Project Name:	Proposed Residential Development, Hemingfield, Barnsley				
Client:	Hargreaves Land Limited				
Subject:	Technical Note - Response to Highways Consultation Comments				
BGH Reference:	23-160-004.04				
Date:	22 nd August 2024				
Prepared by:	P Pitcher	Checked by:	R Donaldson	Overview by:	S Wilkins

HIGHWAYS DEVELOPMENT CONTROL
CONSULTATION RESPONSE

Stage 1 Road Safety Audit

Stage 1 Road Safety Audit Designer's Response

Rev:	Date:	Amendment:	DRN	CHK	APR
Client:			HARGREAVES LAND LTD		
Project:			STAGE 1 RSA - HEMINGFIELD, BARNESLEY		
Drawing No:			23/160/RSA/001		
Job No:			23-160		
Revision:			-		
Date:			19.07.2024

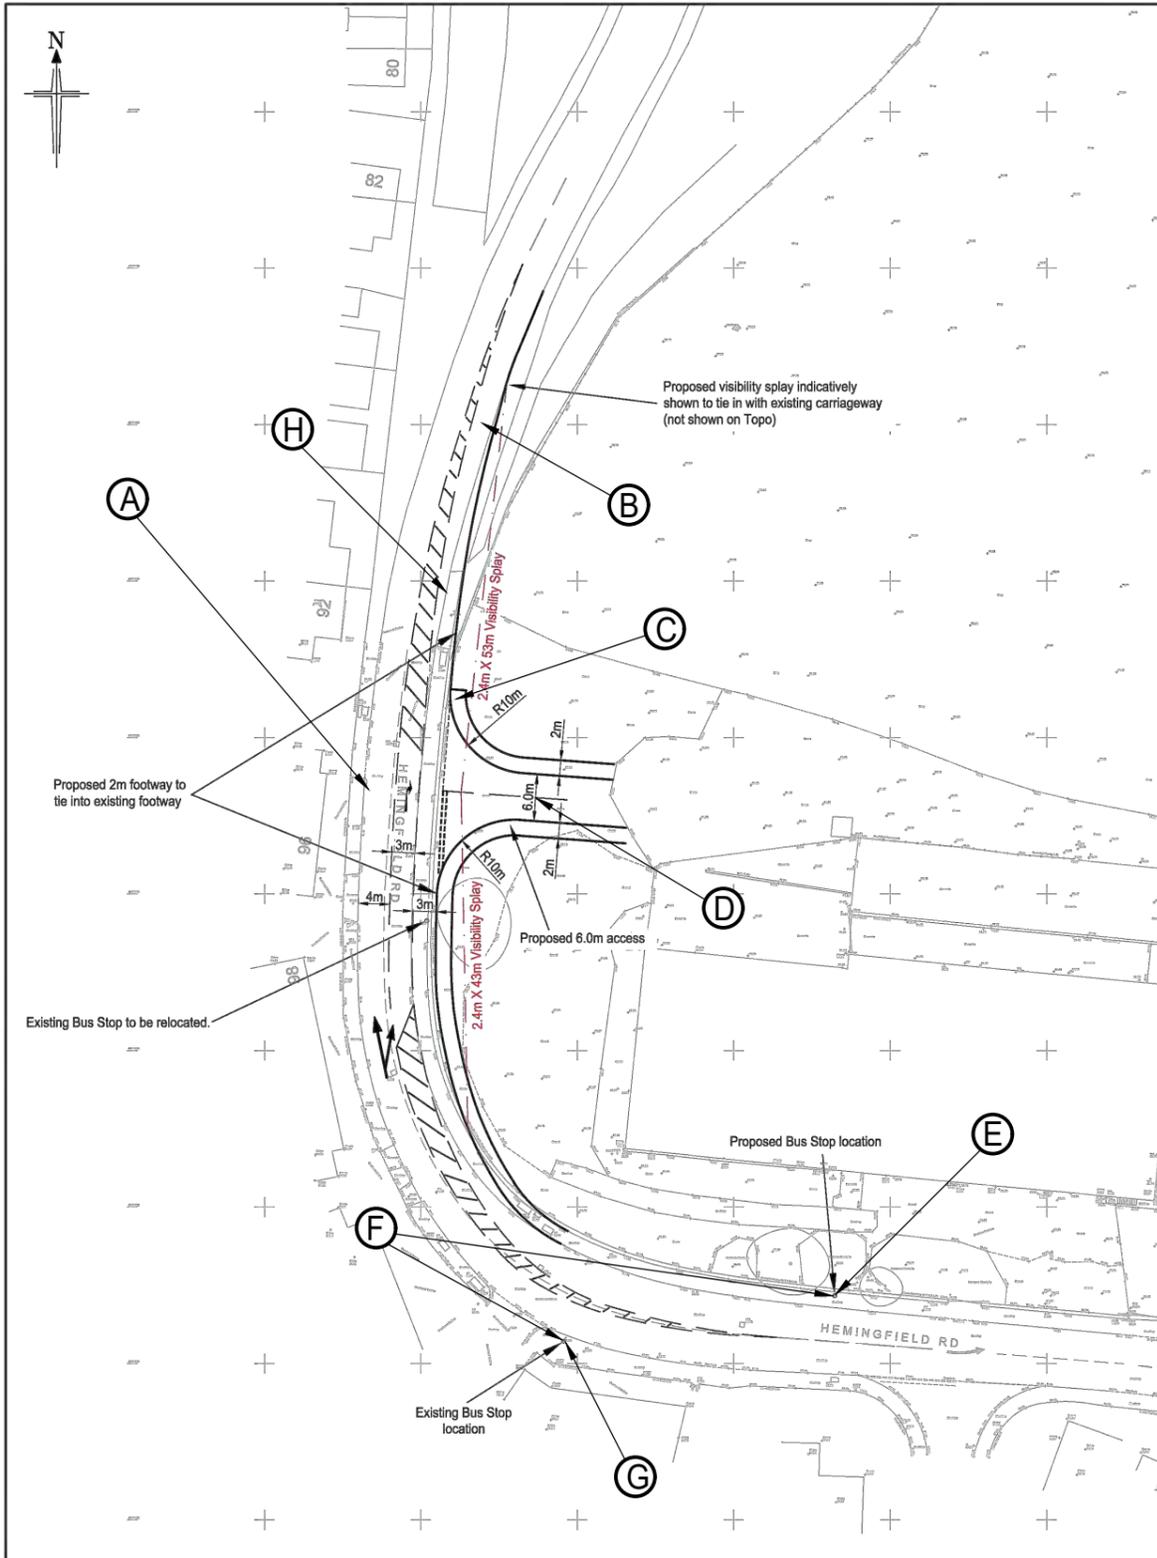
2.1 All items raised within this RSA are shown on the annotated plan at **Appendix BGH1**.

2.2 **Problem A**

Parking on western side of Hemingfield Road opposite the proposed site access.

Provide sufficient stopping sight distance on approach to the proposed new junction from the north.

Drawing No: 23/160/SKH/007 Revision: E
 Job No: 23-160 Date: 13.10.23

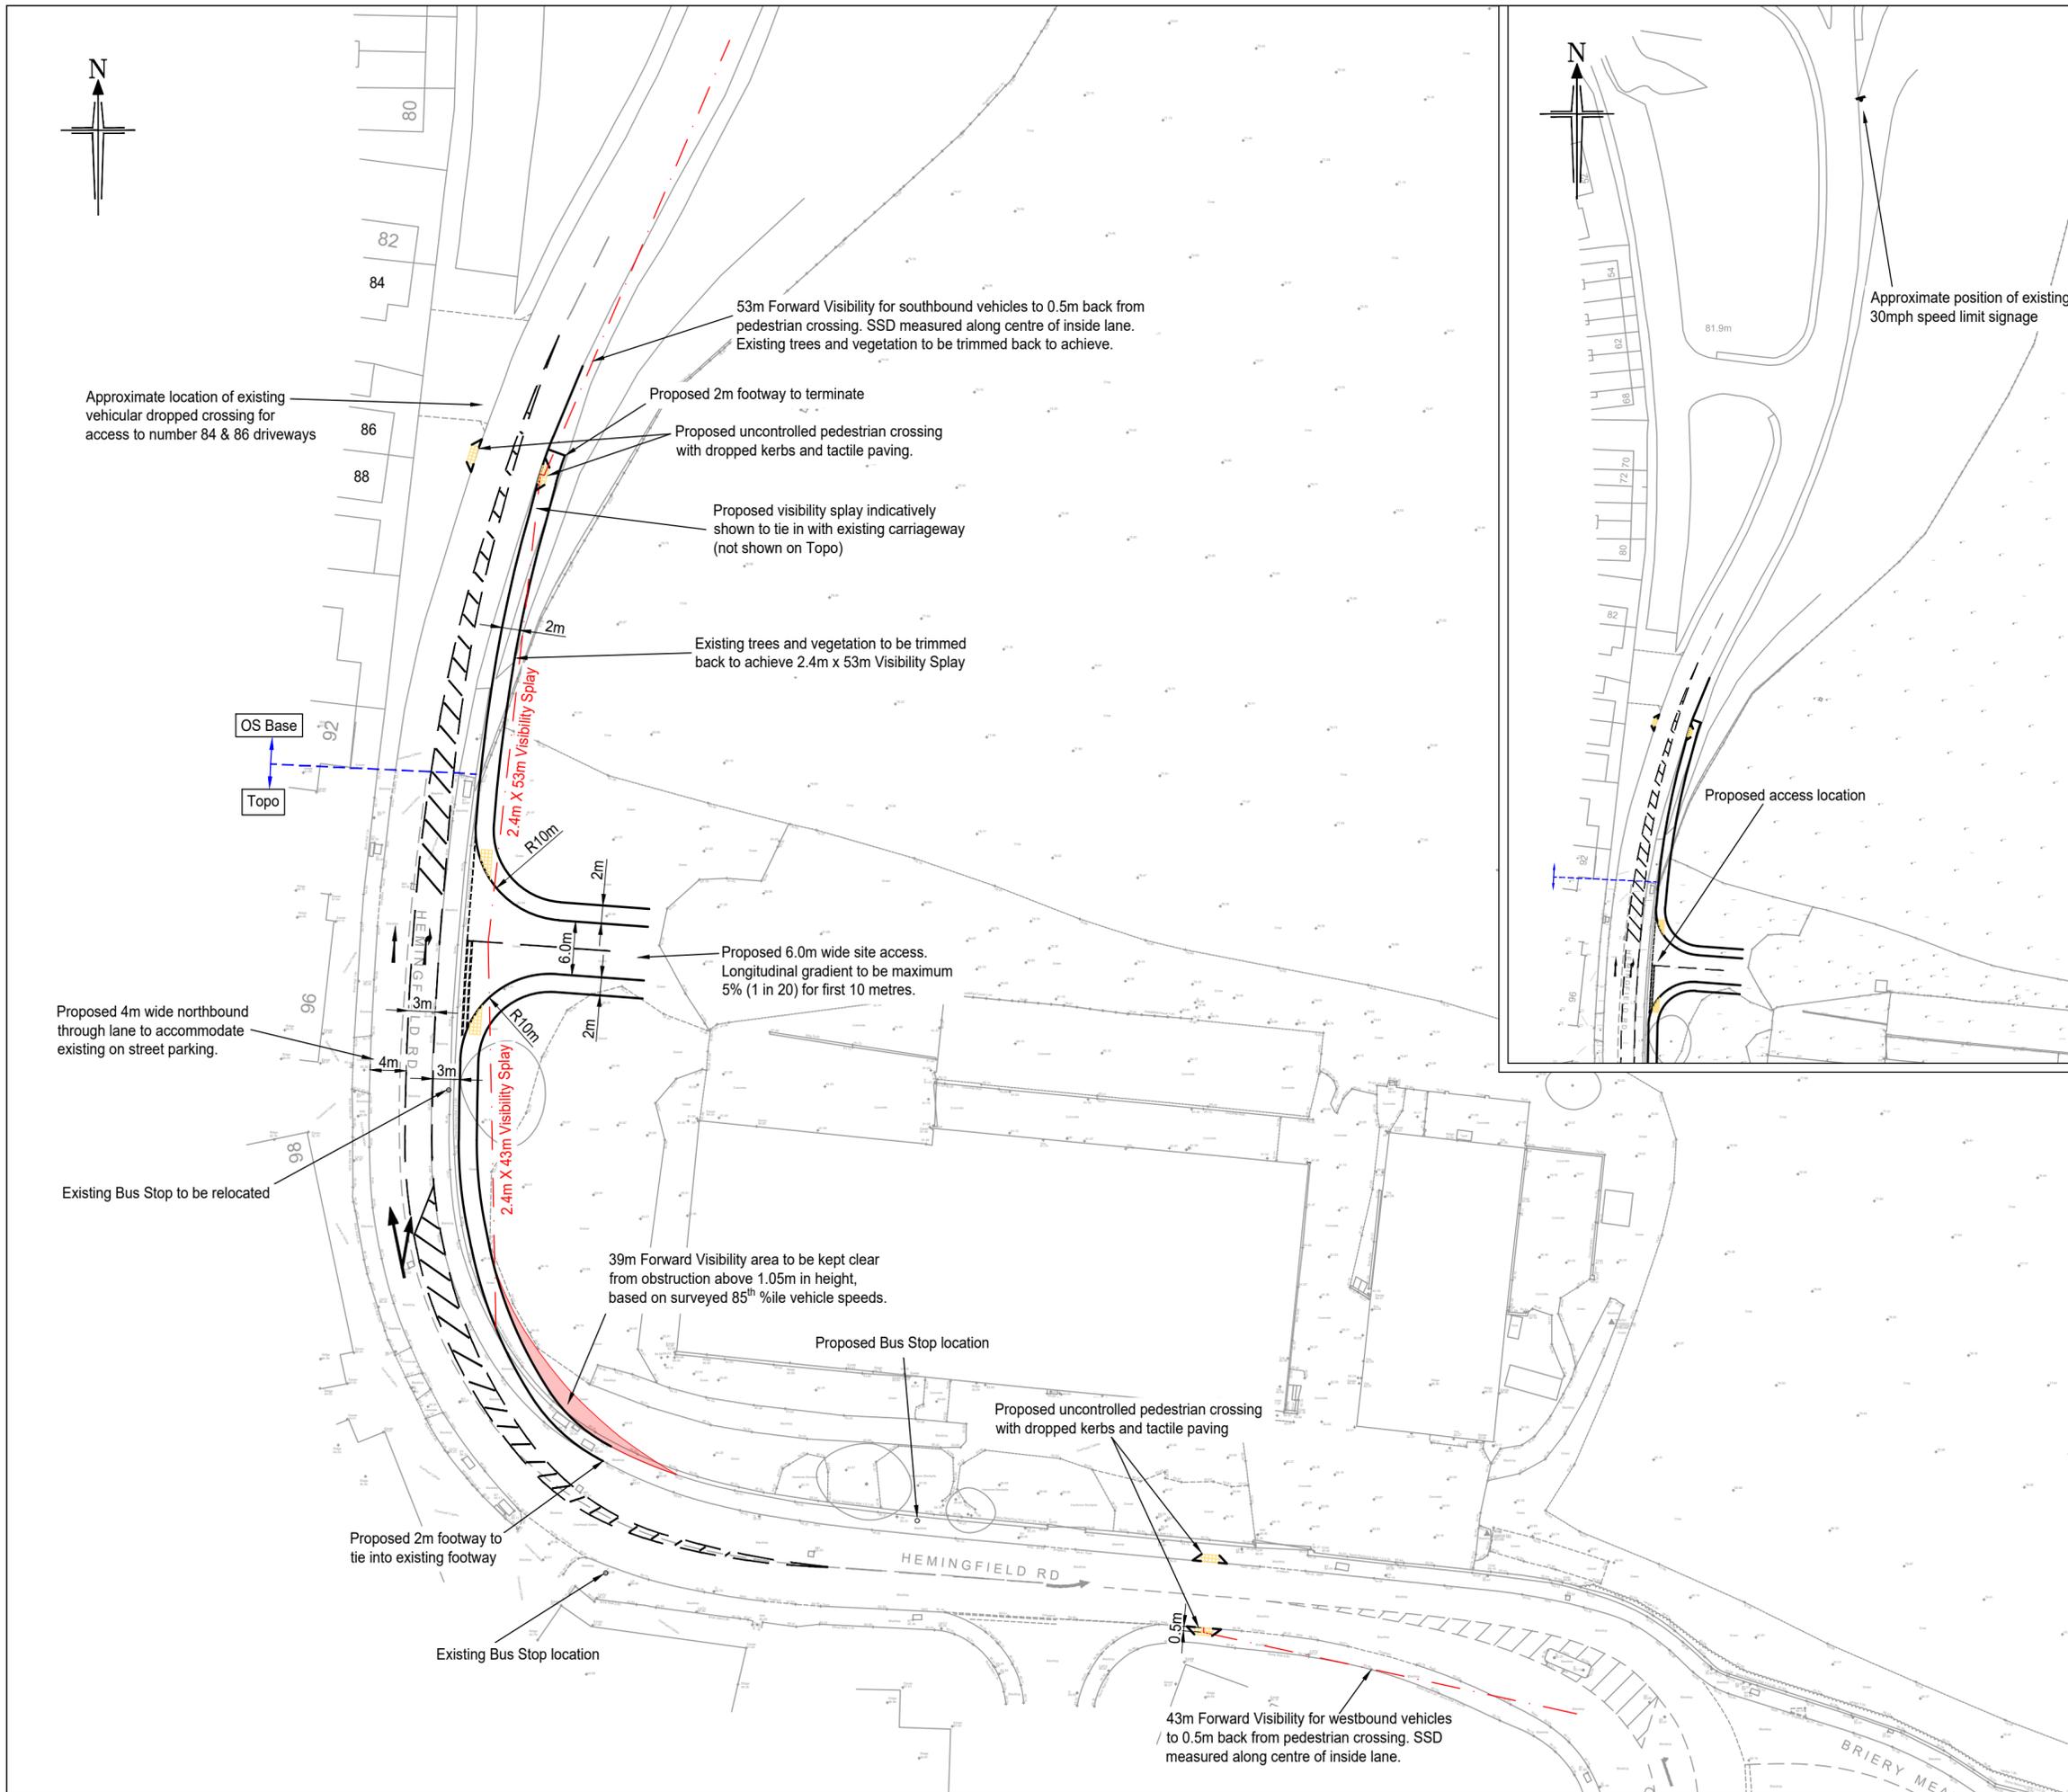
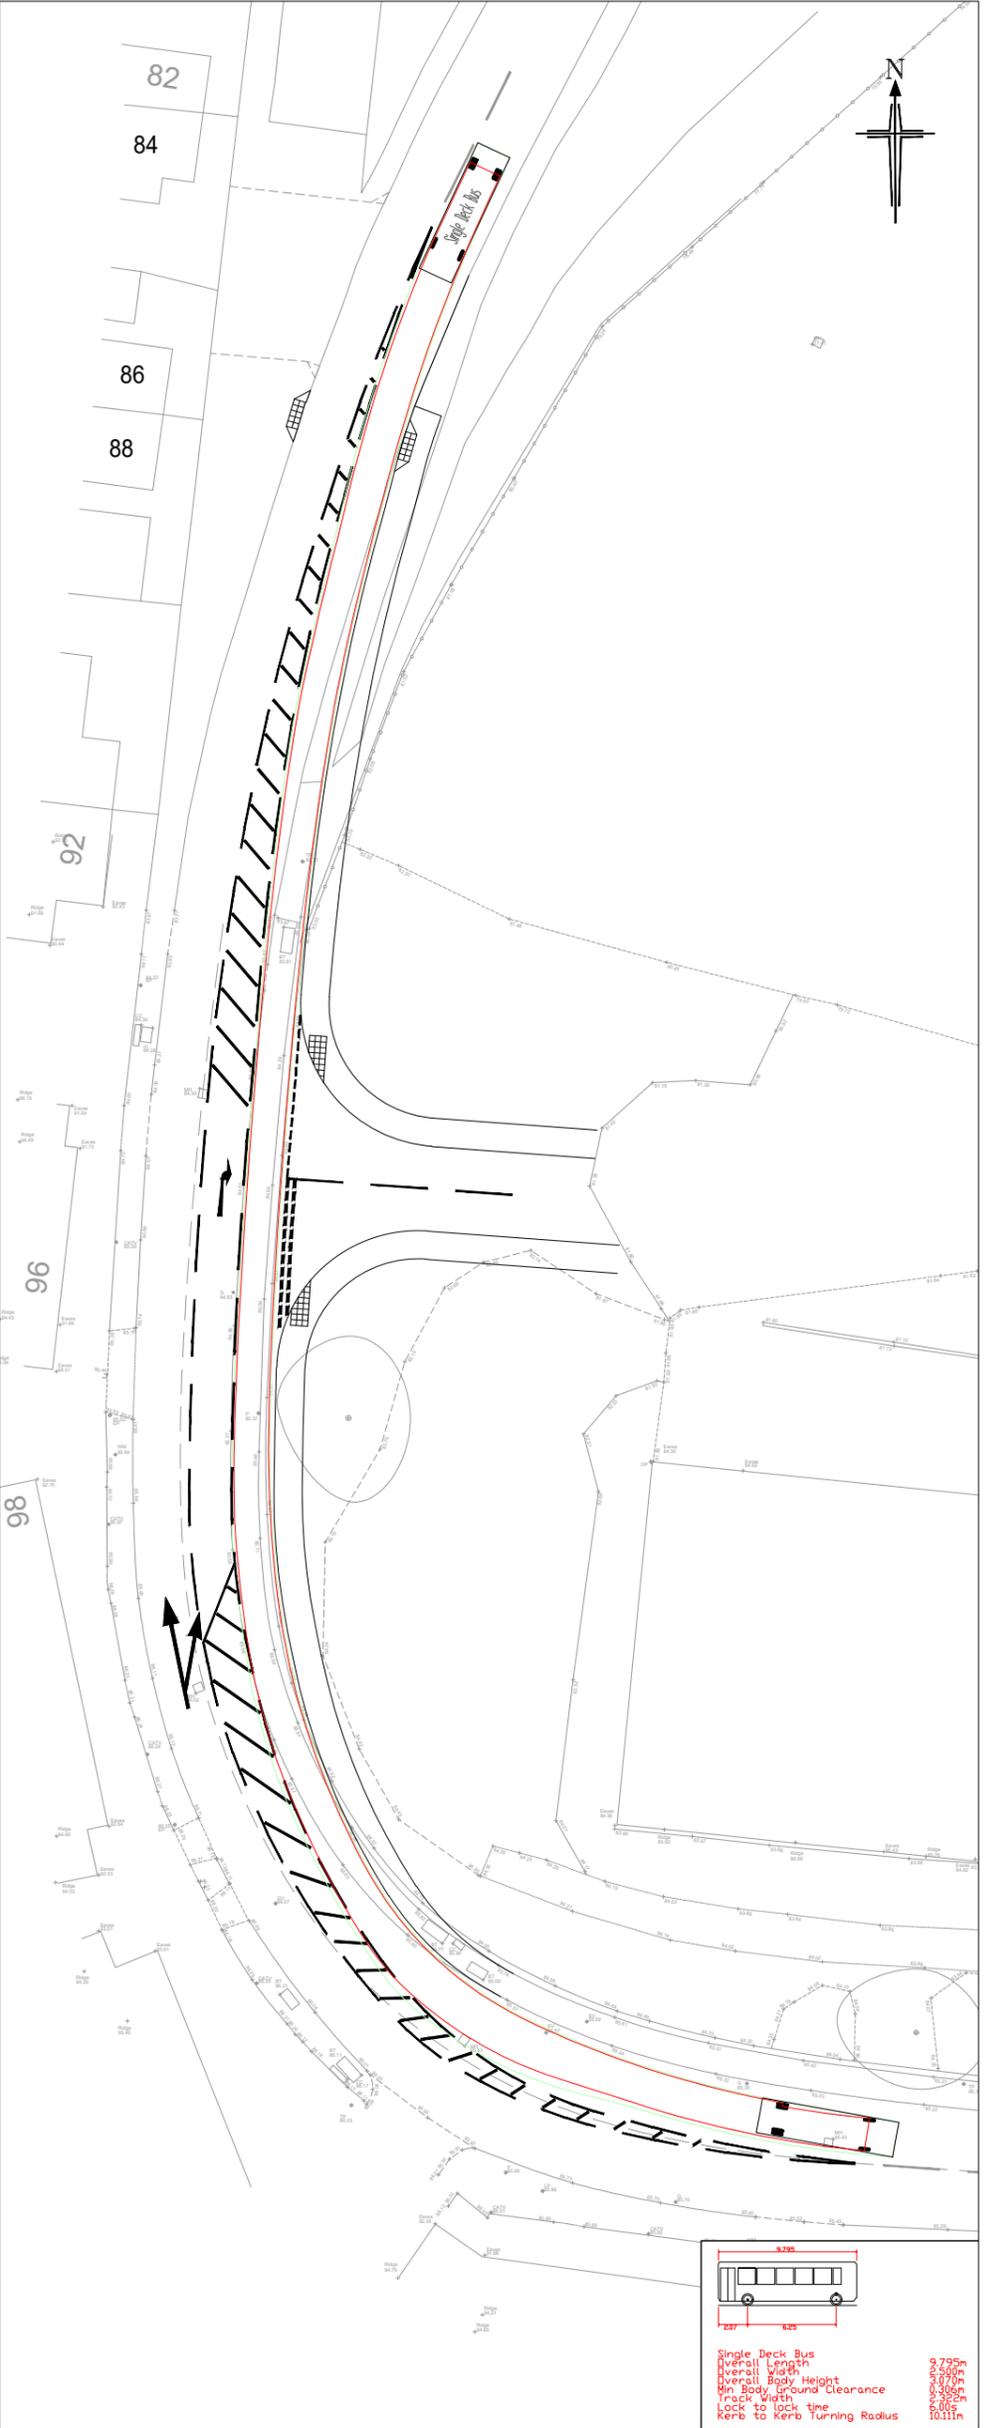
Although the application is outline except for access, Highways DC officers would wish to be provided with a detailed design of the proposed access to ensure it can be constructed adequately up to and including the first spur off within the proposed estate.

Given the proliferation of sustainable transport routes within and adjacent to the site, Highways DC would ask that a 3.0m shared-use path is provided rather than the 2.0m footways shown on the submitted plan. Consideration should also be given to widening the carriageway at the access point, this is firstly due to the number of dwellings it would serve and also to allow the maintenance of two-way flow of traffic should work be required to be carried out at the junction.

7. The above design matters were discussed during the meeting held with BMBC Highways DC on 19th April 2024. Firstly, with regard to the request for a detailed design and Stage 1/2 Road Safety Audit (RSA) of the proposed site access, it has been agreed with BMBC that this is not necessary for the planning application. However, it was agreed that a Stage 1 RSA of the proposed vehicular site access general arrangement would be undertaken and this is attached at **Appendix BGH2**. The Designer's Response to the Stage 1 RSA is attached at **Appendix BGH3** and a revised proposed site access drawing, which has been amended to address the issues raised in the Stage 1 RSA, is attached at **Appendix BGH4** (drawing number 23/160/SKH/007 Rev E).

9. During the meeting in April, BMBC Highways DC requested confirmation of the gradient of the initial part of the proposed site access to the east of Hemingfield Road. Paragraph B.1.5.4 of the South Yorkshire Residential Design Guide (SYRDG) states that on the minor arm approach to a junction, a maximum gradient of 5% (1 in 20) is required for a minimum distance back from the give way line of 5 metres, or up to the tangent point of the corner radii if greater. As the proposed junction kerb radii are 10 metres, the longitudinal gradient of the proposed site access will therefore be no greater than 5% for the first 10 metres. A note has been added to the proposed site access drawing to reflect this.

The proposed site access drawing has been revised to address the comments raised by the audit team and is included at **Appendix BGH1** of this Designer's Response, along with an additional supporting swept path analysis drawing at **Appendix BGH2**, as detailed in this Designer's Response.

RSA Problem	RSA Recommendation	Design Organisation Response	Overseeing Organisation Response	Agreed RSA Action
		<p>then the northbound vehicle would simply need to wait briefly for the right turning car to clear. The modelling of the proposed site access junction shows that there would be minimal delays to vehicles turning right into the site of around 6/7 seconds and that queuing of more than 1 vehicle is not likely to occur, therefore this is not considered to be an issue.</p> <p>Furthermore, at present, it is apparent that vehicles may have to encroach into the opposing carriageway to pass the parked vehicles. Therefore, it is considered that the proposed site access arrangement represents an improvement over the existing situation.</p>		
Problem B				
Hemingfield Road southbound approach to the proposed site access.	Provide sufficient stopping sight distance on approach to the proposed new junction from the north.	<p>In response to Problem C, a footway is now proposed to the north of the access, which will necessitate the removal of some vegetation in this area. Any remaining vegetation within the adopted highway is to be trimmed back as necessary to achieve the 2.4 metres x 53 metres visibility splay to the north.</p> <p>A note has been added to the proposed site access drawing to clarify this.</p>

RSA Problem	RSA Recommendation	Design Organisation Response	Overseeing Organisation Response	Agreed RSA Action
		<p>pedestrians on the eastern side of the crossing at a point 0.5 metres back from the dropped kerb. The 53 metres stopping sight distance has been measured along the centre of the southbound carriageway. The existing trees and vegetation will be trimmed back as necessary to achieve this forward visibility.</p> <p>On the western side of the carriageway, the proposed crossing is located where existing dwellings have private driveways and some additional block paved space in front of the properties to park off the carriageway. Therefore crossing pedestrians are very unlikely to be masked by vehicles parked on Hemingfield Road.</p>		
Problem D				
Site access pedestrian crossing facilities	It is recommended that tactile paving and dropped kerbs are provided at a suitable location on the desire line across the minor arm of the proposed junction.	An uncontrolled pedestrian crossing with dropped kerbs and tactile paving will be provide at the proposed site access as suggested. The proposed site access has been amended to show this.
